Re: **Initial Submission Review** – Green Valley Ranch East Site Plan No 6 Amdt – Site Plan Amendment and Replat
Application Number: **DA-1662-33**
Case Numbers: 2023-3055-00; 2021-4012-01

The following are written responses to the City comments dated November 17, 2023 for your review. We have also included responses on the redlines PDF for your review.

GREEN VALLEY RANCH EAST SITE PLAN #6

Project Number: 50119125
Designed By: Drawn By: SDG JTM
Checked By: SOS
Sheet Number: 8

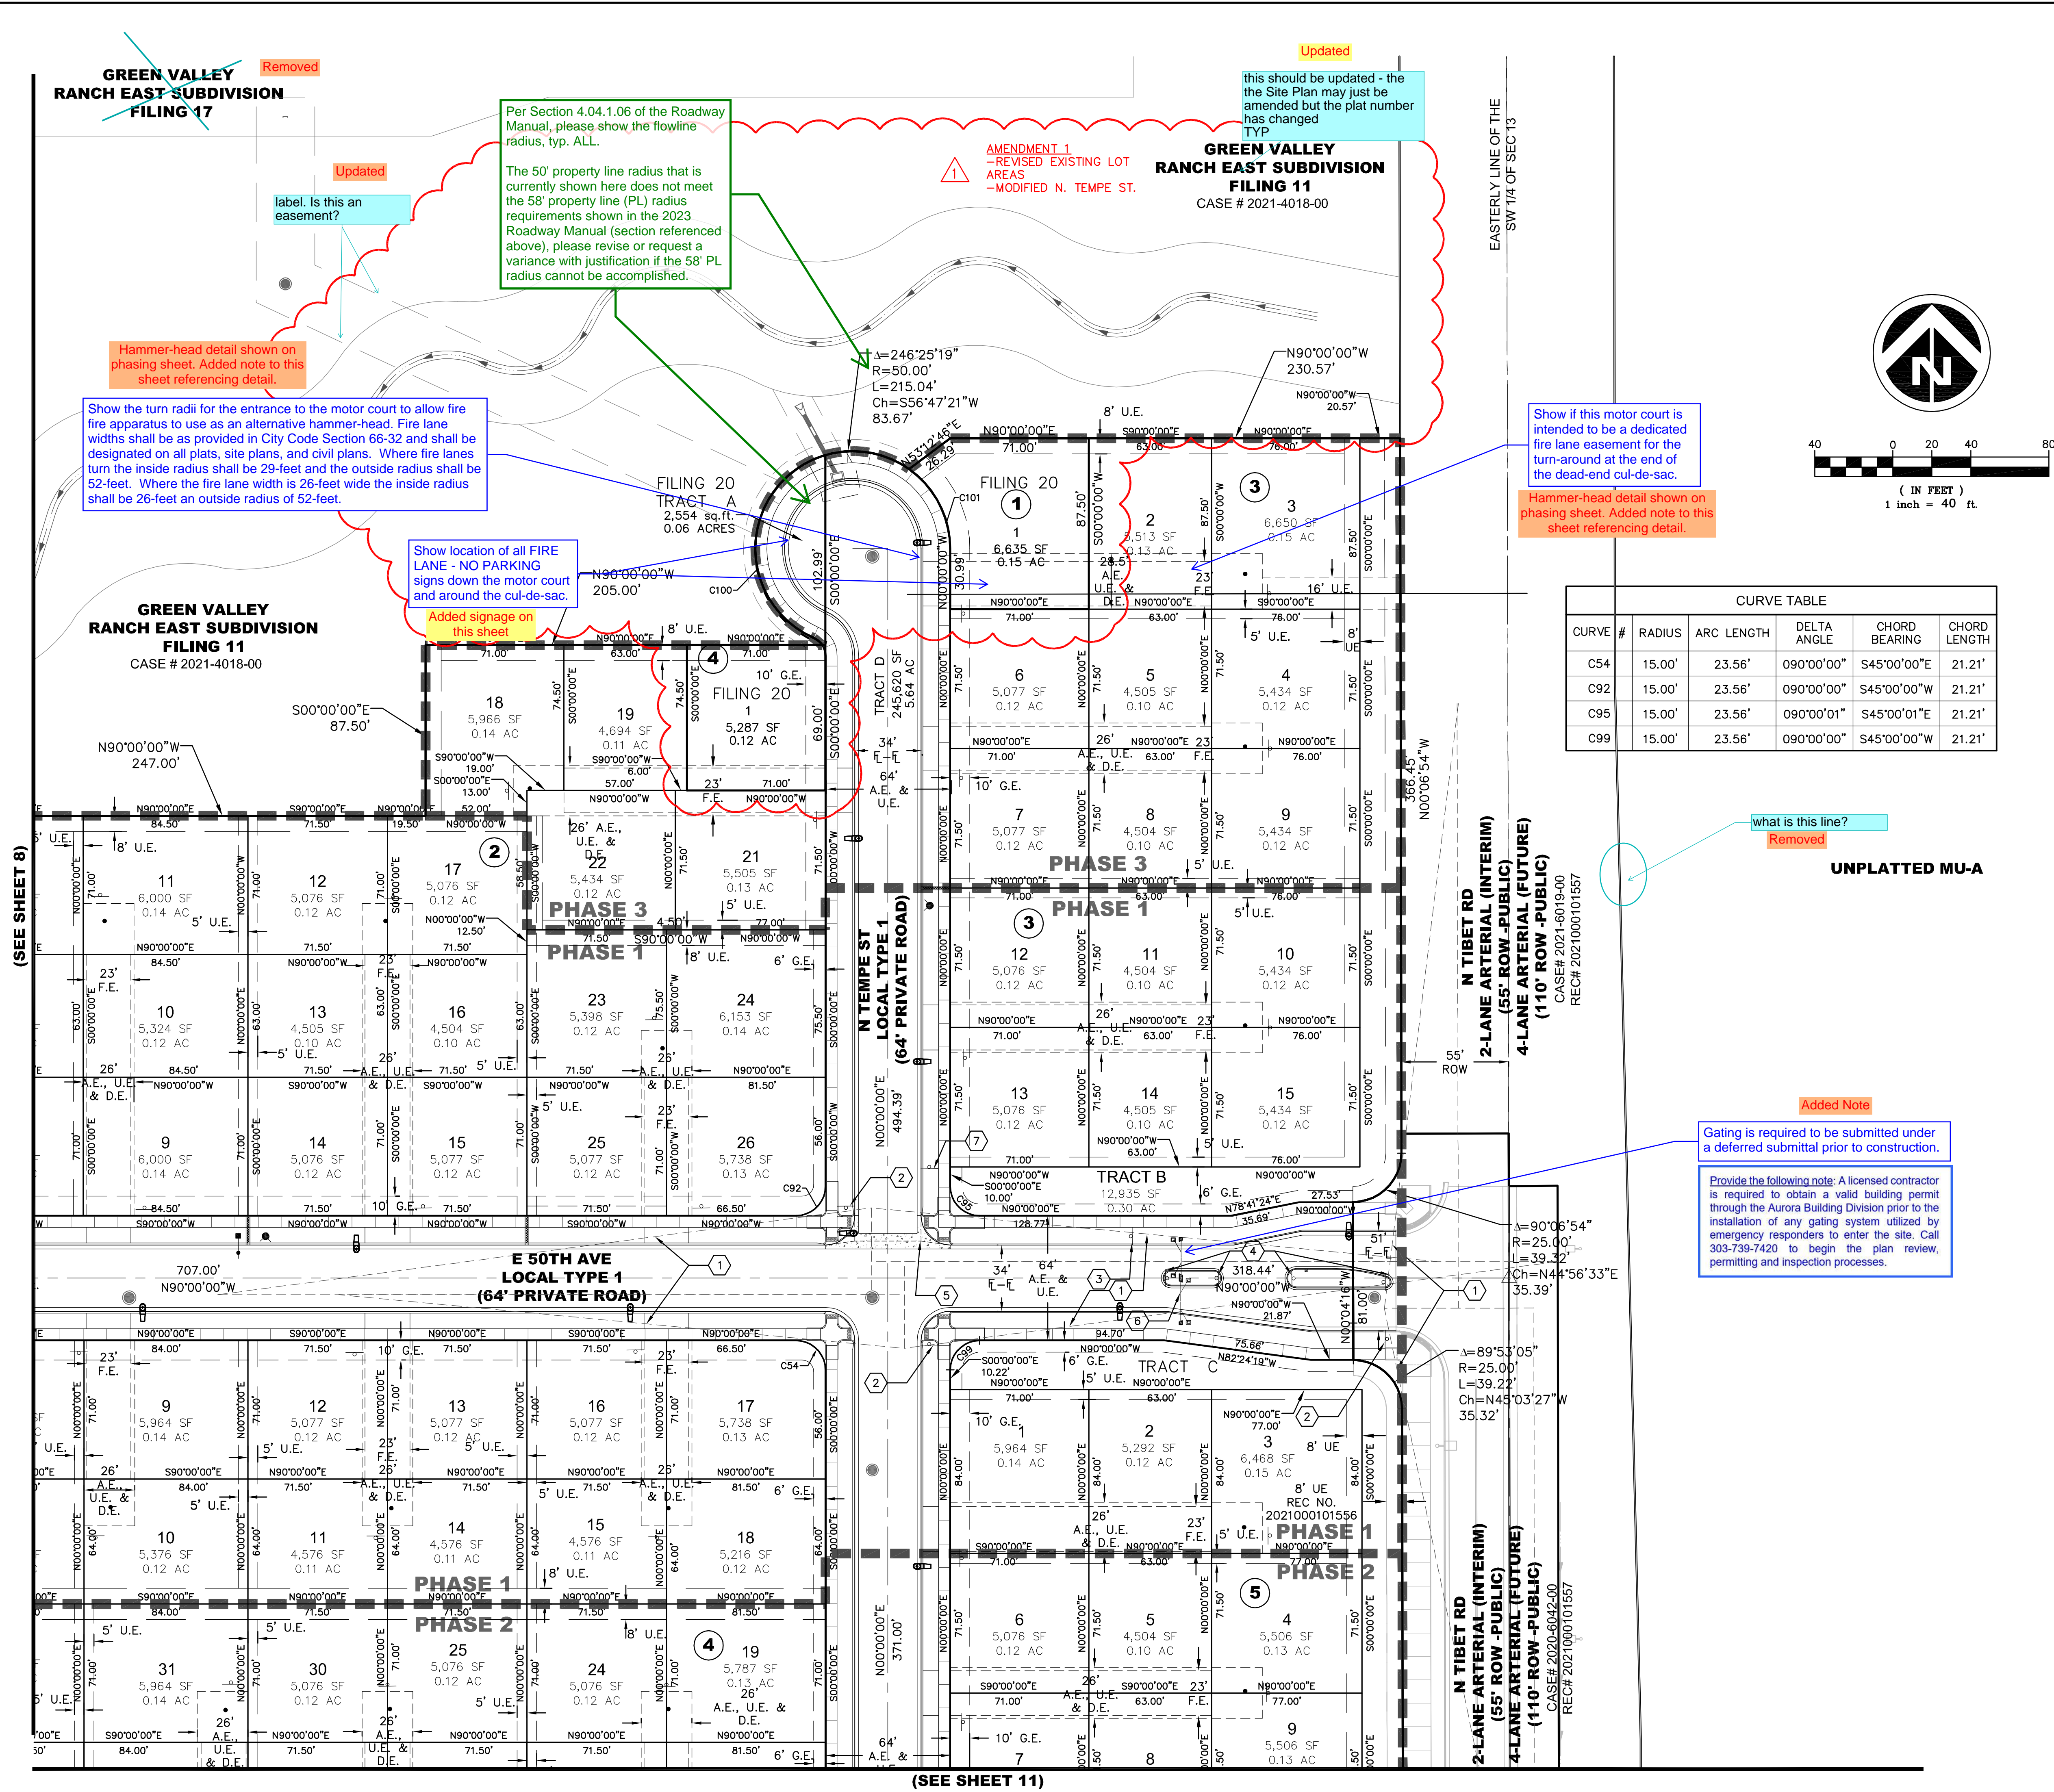
4C. Label the linetype noted on Sheet 8. **RESPONSE:** Labeled

Project Number:	Drawn By:	Checked By:	Sheet Number:
50119125	SDC JTM	SOS	9

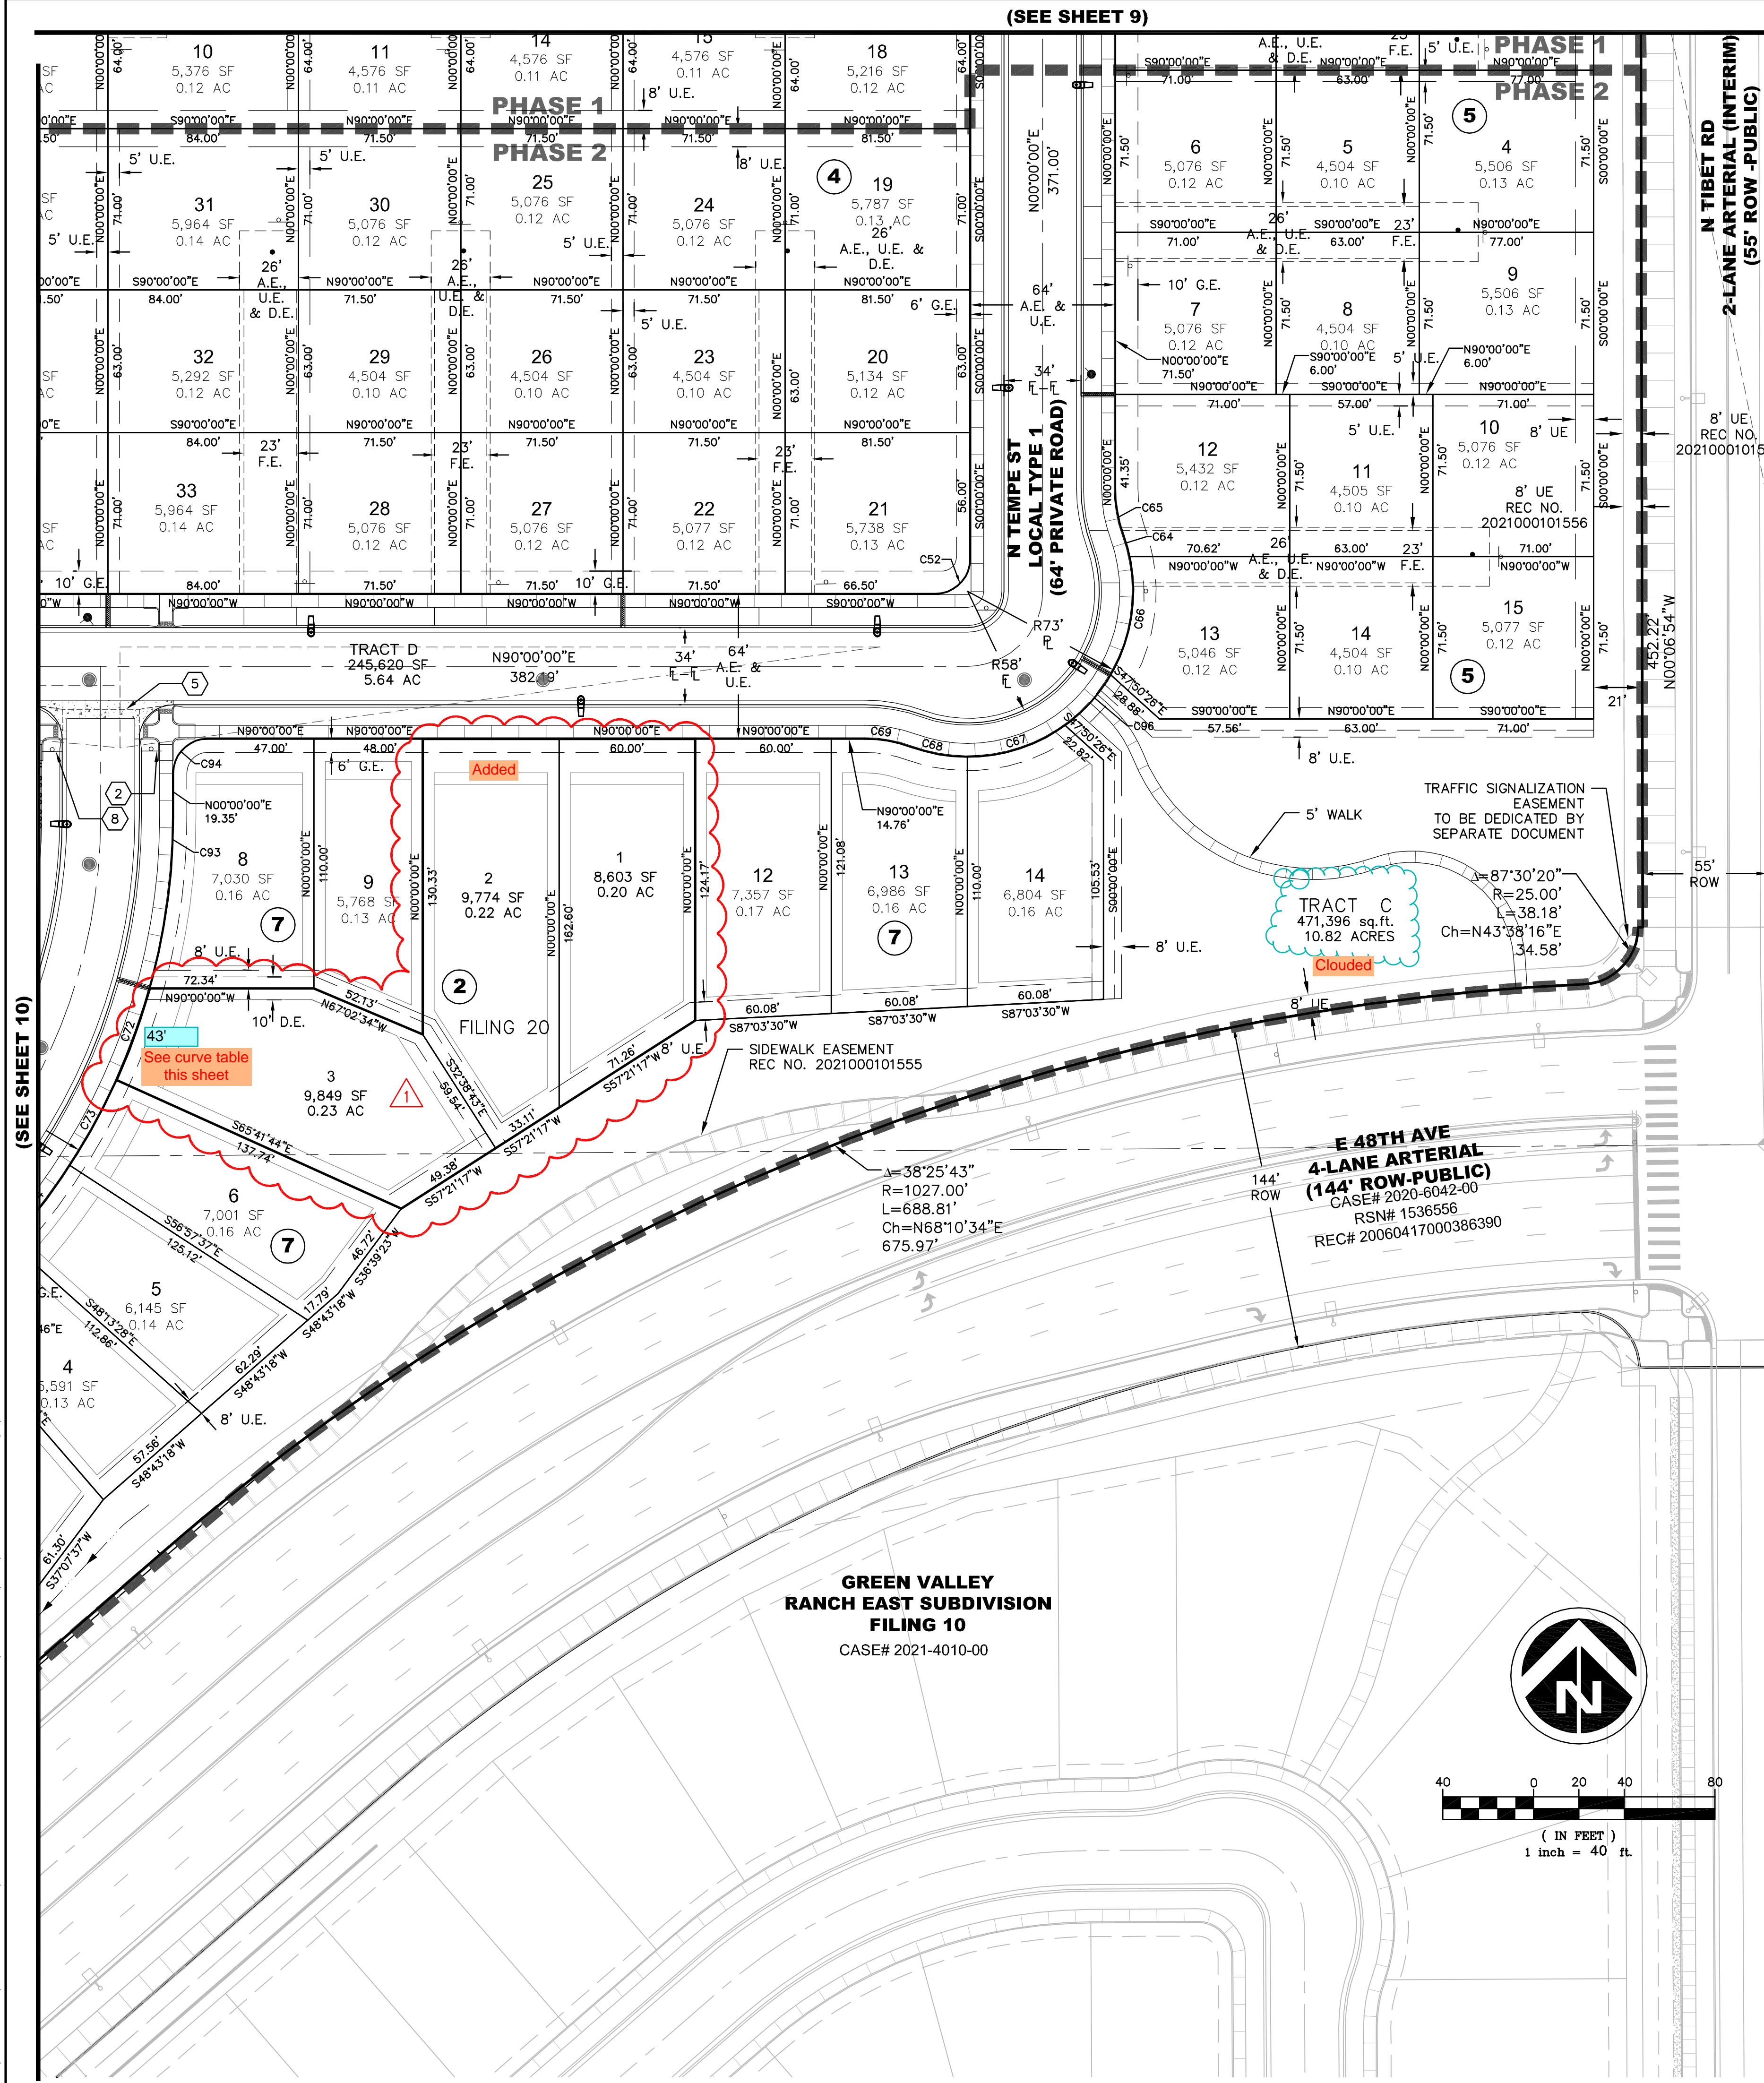
6A. Show the turn radii for the entrance to the motor court to allow fire apparatus to be used as an alternative hammerhead. Fire lane widths shall be as provided in City Code Section 66-32 and shall be designated on all plats, site plans, and civil plans. Where fire lanes turn the inside radius shall be 29 feet and the outside radius shall be 52 feet. Where the fire lane width is 26 feet wide the inside radius shall be 26 feet and the outside radius of 52 feet. **RESPONSE:** Hammerhead shown on phasing sheet and updated for cul-de-sac.

6B. Show the location of all FIRE LANE - NO PARKING signs down the motor court and around the cul-de-sac. **RESPONSE:** No parking signs added and locations shown.

6C. Show if this motor court is intended to be a dedicated fire lane easement for the turn-around at the end of the dead-end cul-de-sac. **RESPONSE:** Motor court is a fire lane easement intended to be used as a turn around.
